Access Compliance Report

Public Rights-of-Way

(Curb Ramps)

Intersection ID: 9373	Main Street: EUREKA_ST	Cross Street: GENESIS_PARK_PL	Location: SW
ADA ID: DEB2197526AE	Ramp Type: Perp	Initial Pass/Fail: Fail	Overall Compliance: No
Severity Score: 21.25			
Codes/Mitigation Info/Possible Solution		Field Measurements/Component Compliance

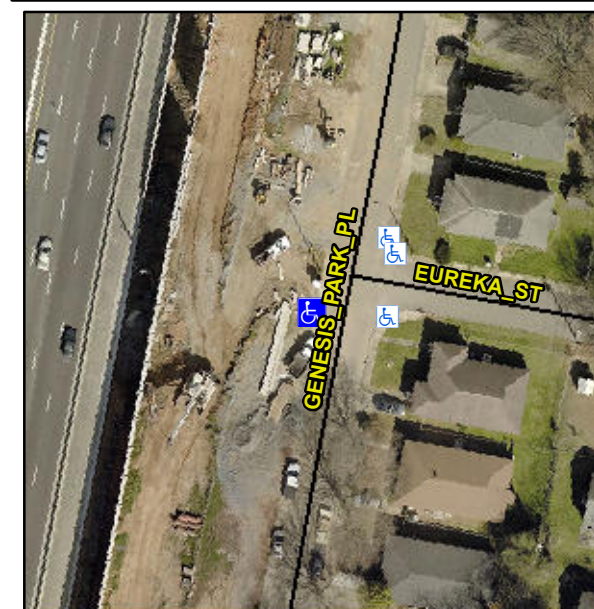
R304.5.1, R304.2.2

Compliance	Description	Data	Compliance	Description	Data
N/A	Ramp Length (in)	55.0	No	Ramp Slope (%)	9.0
No	Ramp Width (in)	46.0	Yes	Ramp XSlope (%)	1.2
N/A	Flare Type LT	N/A	N/A	Flare Type RT	N/A
N/A	Flare Slope LT (%)	N/A	N/A	Flare Slope RT (%)	N/A
N/A	Flare Traversable LT?	N/A	N/A	Flare Traversable RT?	N/A
N/A	Landing Length (in)	N/A	N/A	DWS Provided?	N/A
N/A	Landing Width (in)	N/A	N/A	DWS Contrast?	N/A
N/A	Landing Slope (%)	N/A	N/A	DWS Length (in)	N/A
N/A	Landing X Slope (%)	N/A	N/A	DWS Full Width?	N/A
N/A	Landing Curb? (Y/N)	N/A	N/A	DWS Offset (in)	N/A
N/A	Shared Landing?	N/A			
N/A	Gutter Ponding?	N/A	N/A	Gutter Slope (%)	N/A
N/A	Gutter Lip Ht (in)	0.5	N/A	Gutter X Slope (%)	N/A
N/A	Painted X Walk1?	No	N/A	Painted X Walk2?	N/A
	X Walk 1 Direction	To SE		X Walk 2 Direction	N/A
N/A	X Walk 1 Width (in)	N/A	N/A	X Walk 2 Width (in)	N/A
	X Walk 1 Slope (%)	7.1		X Walk 2 Slope (%)	N/A
	X Walk 1 X Slope (%)	1.7		X Walk 2 X Slope (%)	N/A

N/A	Ramp inside XWalk1?	N/A	N/A	Ramp inside XWalk2?	N/A
	Road Slope (%)	N/A	N/A	Clear Space?	N/A
	Road X Slope (%)	N/A	N/A	Clear Space to XWalk (in)	N/A
N/A	Any Obstructions?	N/A	N/A	Storm Grate/Utility Hazard?	N/A
	Obstruction Type			Storm Grate/Utility Type	
		N/A			N/A
			Yes	Surface Condition? (G/P)	Good

Remove & Replace Entire Ramp.
